REVISED RESPONSE TO REQUEST FOR ADDITIONAL INFORMATION

APR1400 Design Certification

Docket No. 52-046

RAI No.: 207-8247
SRP Section: 12.02 – Radiation Sources
Application Section: 12.2
Date of RAI Issue: 09/11/2015

Figure 1 MCR Charcoal Filter Shine Geometric Shielding Model

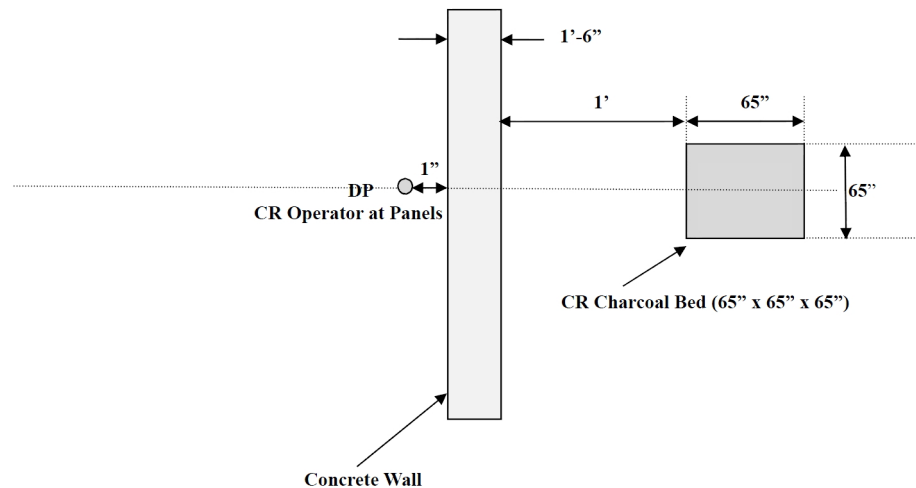
3. Update the FSAR to provide radioactive source dimensions and parameters for major post-accident source term components such as the shutdown cooling pumps and accident emergency control room ventilation filters and identify the locations of these components.

4. Indicate if there are any filters (either normal operation or accident) physically within the main control room or technical support center areas (those areas requiring continuous access). If so, discuss shielding of these filters and the dose from these components during design basis accidents.

Dimensions for the MCR filter is provided in DCD Table 15.6-13 (3 of 3). The geometric model for the MCR charcoal filter shine dose calculation is shown in Figure 1. This model is based on the location of the MCR ACU and surrounding concrete shielding. In the shielding analysis, the charcoal tray of height 1.65 m is conservatively used.

- There are no additional filters to be considered in the shielding analysis within the CRE except for the emergency makeup ACU.
- The CRE is designed in accordance with the design requirements in 10 CFR Part 50, Appendix A, GDC 19, and is shielded so that, after a postulated DBA, radiation exposure in the CRE for the duration of the accident does not exceed 50 mSv TEDE.
